Access Compliance Report

Public Rights-of-Way

(Curb Ramps)

Intersection ID: N/A	Main Street: FAIRWOOD_AV	Cross Street: GRUFFITH_ST	Location: N
ADA ID: AC7806D352B9	Ramp Type: Perp	Initial Pass/Fail: Pass	Overall Compliance: No
Severity Score: 0.25			
Codes/Mitigation Info/Possible Solution		Field Measurements/Component Compliance

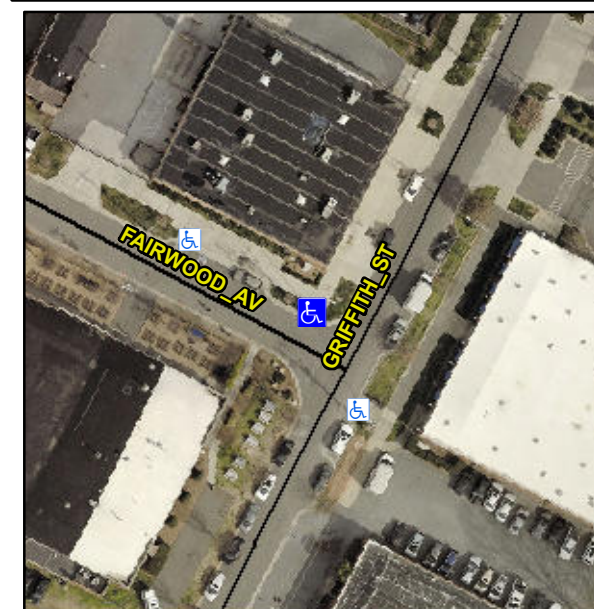
Not Found, R304.5.3

Compliance	Description	Data	Compliance	Description	Data
N/A	Ramp Length (in)	75.0	Yes	Ramp Slope (%)	5.4
Yes	Ramp Width (in)	86.0	No	Ramp XSlope (%)	2.4
Yes	Flare Type LT	Curbed_NoWalkSurface	Yes	Flare Type RT	N/A
Yes	Flare Slope LT (%)	N/A	N/A	Flare Slope RT (%)	N/A
N/A	Flare Traversable LT?	No	N/A	Flare Traversable RT?	No
Yes	Landing Length (in)	96.0	Yes	DWS Provided?	Yes
Yes	Landing Width (in)	85.0	Yes	DWS Contrast?	Yes
Yes	Landing Slope (%)	0.2	Yes	DWS Length (in)	25.5
Yes	Landing X Slope (%)	0.1	Yes	DWS Full Width?	Yes
N/A	Landing Curb? (Y/N)	No	Yes	DWS Offset (in)	2.0
N/A	Shared Landing?	No			
Yes	Gutter Ponding?	No	Yes	Gutter Slope (%)	1.8
Yes	Gutter Lip Ht (in)	0.0	No	Gutter X Slope (%)	2.8
N/A	Painted X Walk1?	No	N/A	Painted X Walk2?	N/A
	X Walk 1 Direction	To SW		X Walk 2 Direction	N/A
N/A	X Walk 1 Width (in)	N/A	N/A	X Walk 2 Width (in)	N/A
	X Walk 1 Slope (%)	1.8		X Walk 2 Slope (%)	N/A
	X Walk 1 X Slope (%)	2.0		X Walk 2 X Slope (%)	N/A

Remove & Replace Entire Ramp.
Remove & Replace Gutter.
